DATE: 01.23.2019
TO: ProTrak
FROM: Mitesh Baxi
Traffic Engineering

■ CAPE FEAR CENTER FOR INQUIRY PARKING LOT ADDITION [TRC Plan Review]

Initial Review Note

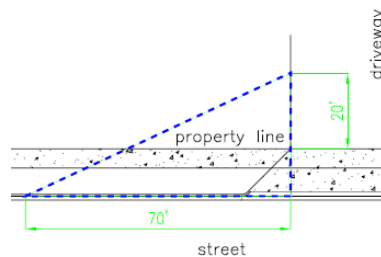
- Revise all sheets to accurately illustrate the existing conditions on and surrounding this parcel. Show all adjacent traffic signs, lane configurations, traffic control devices and pavement markings for the Shipyard Blv on the site inventory plan. Please refer to the Technical Standards and Specifications Manual (link is below) Ch. VII C.1.a.2. for specific information and distance requirements. Contact Traffic Engineering at 341-7888 if you need assistance locating these elements.
<https://www.wilmingtonnc.gov/home/showdocument?id=1910>
- There is an existing U.S. route sign in front of the property. It must be relocated in accordance with the MUTCD/NCDOT.
